12_01 4 in. Concrete Island Cover Payitem

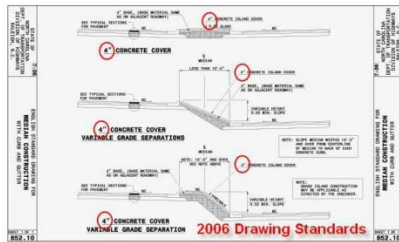
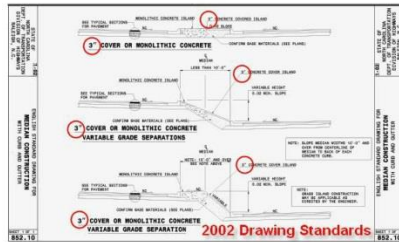
I have a median concrete island (8' wide) with a 2'-6" curb and gutter. Standard calls for a 4" concrete cover. You have 3" and 12" concrete covers in D&C Manager but no 4". Should I use the 3" island cover instead?

The 3" Concrete Island Cover payitem should not be used in lieu of the 4" Concrete Island Cover payitem. The Roadway Payitem D&C Manager has been modified to include the 4" Concrete Island Cover payitem.

Note that in the April 3rd, 2006 memo entitled New and Revised Standard Drawings, Drawing Standard 852.10 (sheet 1 of 1) has been revised to increase the median concrete cover depth from 3" to 4".
